Docket Item # 1&2
BAR CASE # 2014-0026 & 0027

BAR Meeting
March 19, 2014

ISSUE: Permit to Capsulate & Certificate of Appropriateness Application for an Addition and Alterations

LOCATION: 707 Devon Place

PHYSICAL IMPROVEMENTS SURVEY
LOT 55

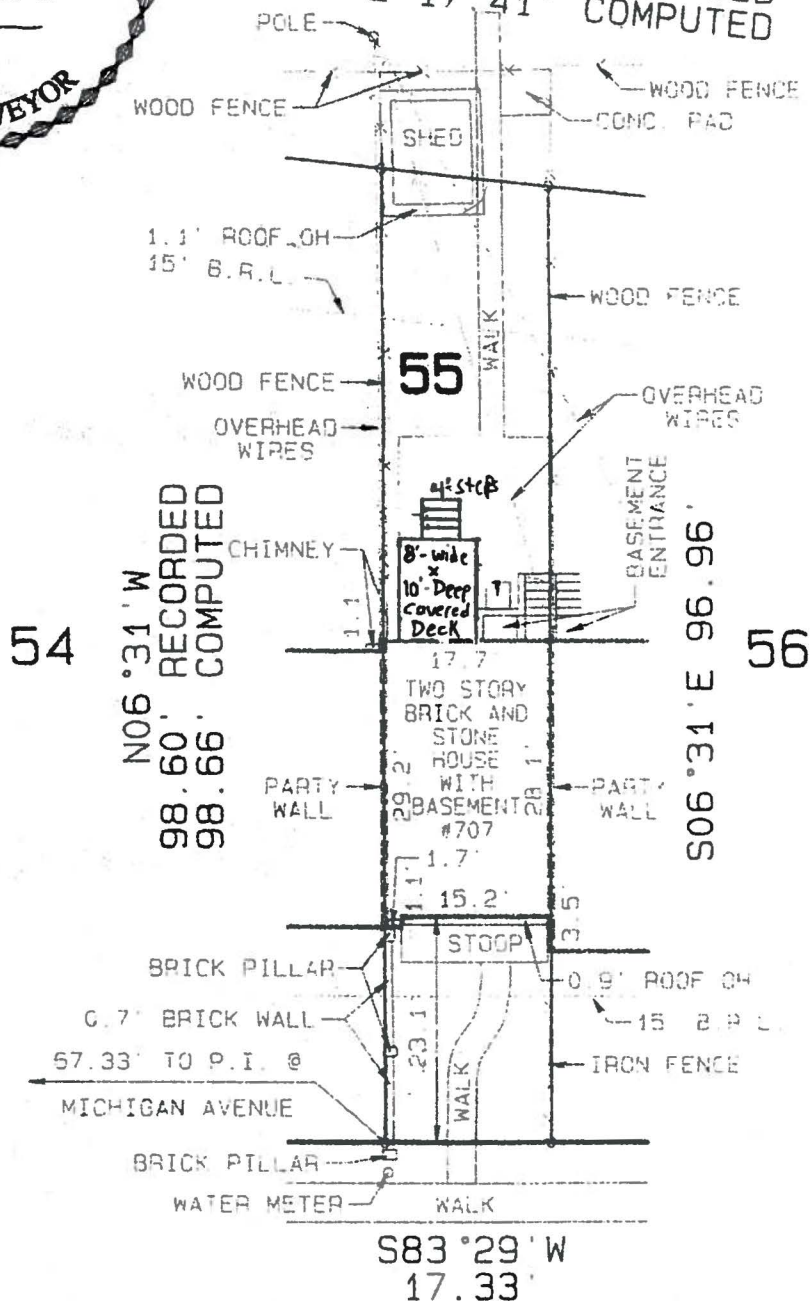
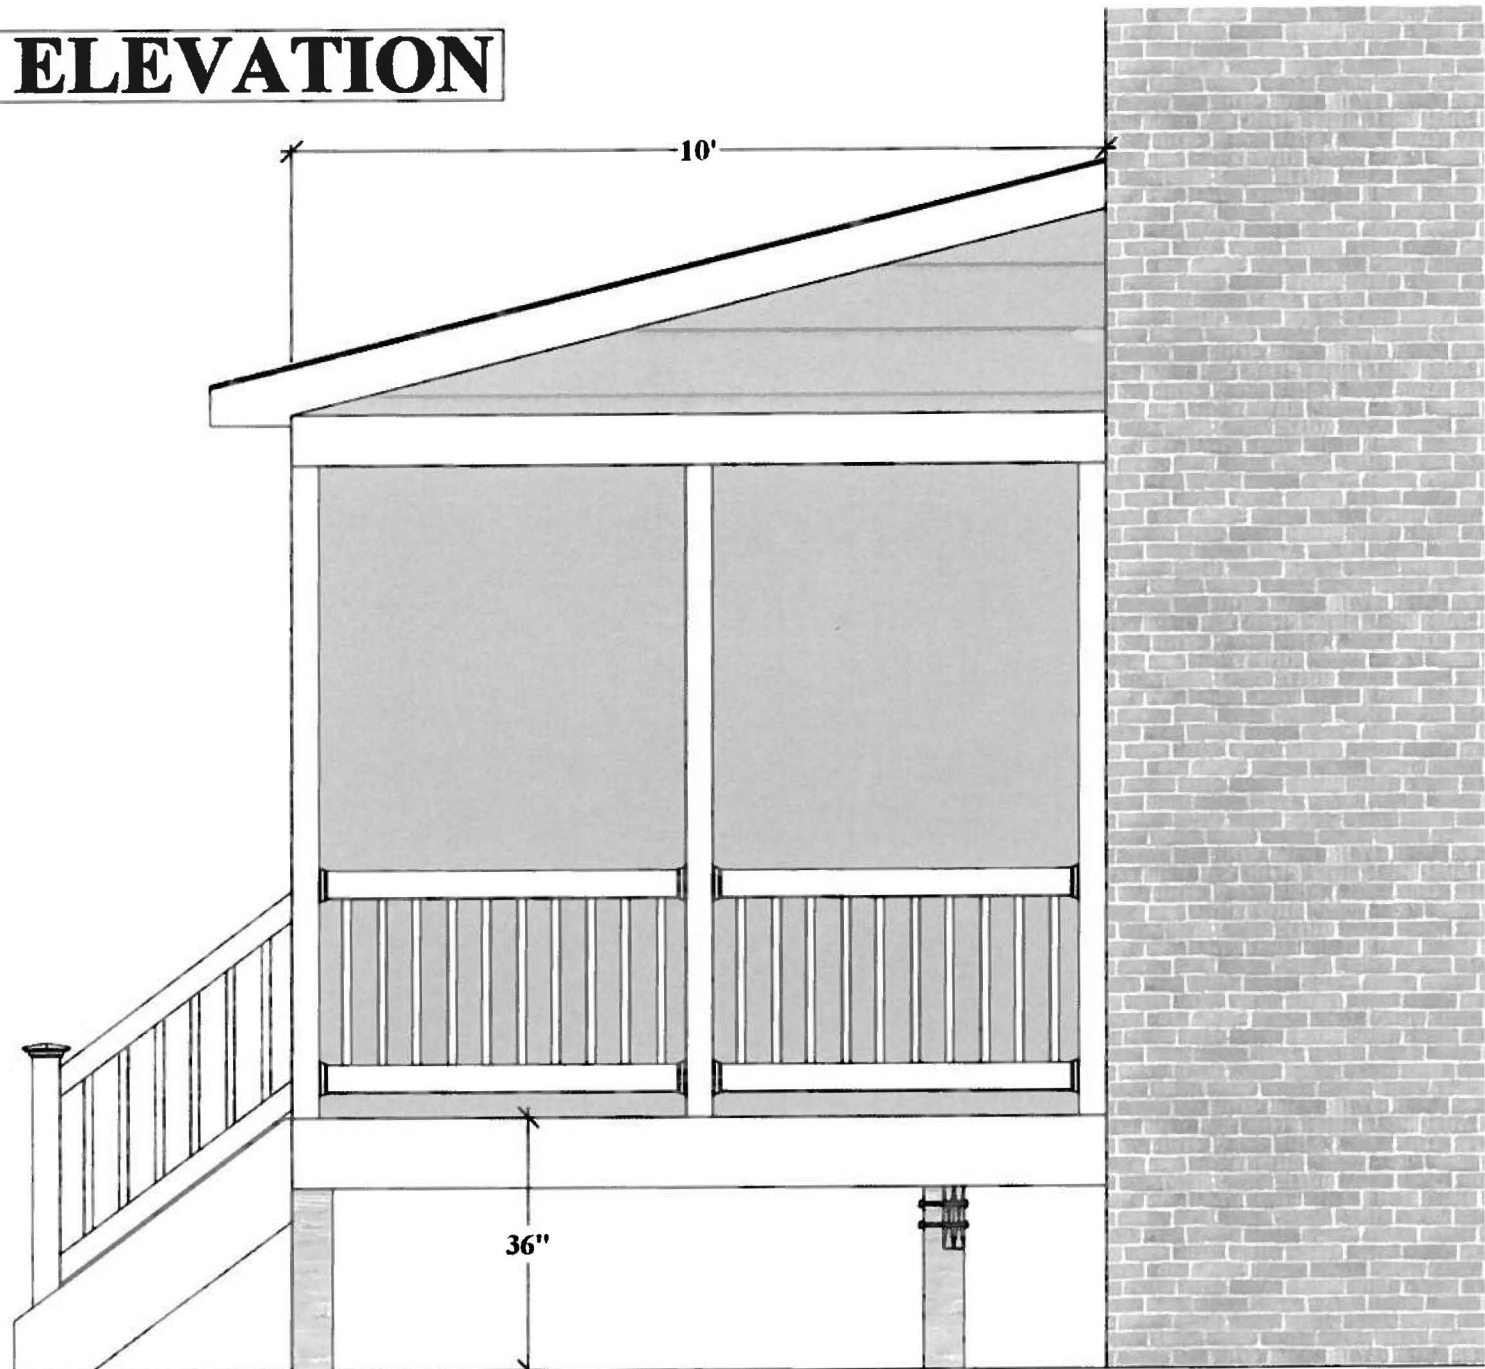
- F-1 Staff recommends the applicant schedule a meeting to discuss the proposed improvements to the property.
- C-1 Existing and proposed shed are not located completely on the subject property.

- C-2 The subject property is a through lot with frontage on Devon Place and Bernard Street. Existing and proposed shed are located forward of the front building wall and across the front property line facing Bernard Street. Applicant must locate the shed on the subject property and request a variance to locate it in the required front yard and forward of the front building wall. Open space will need to be recalculated once the shed is relocated.

- C-3 The dimensions on the plat of the proposed shed and the screened porch appear different from proposed plans. All plans must be consistent.
- C-4 Proposed shed is not a direct replacement of the existing structure. The proposed shed is 9.2' to the ridge and is taller than the existing shed.
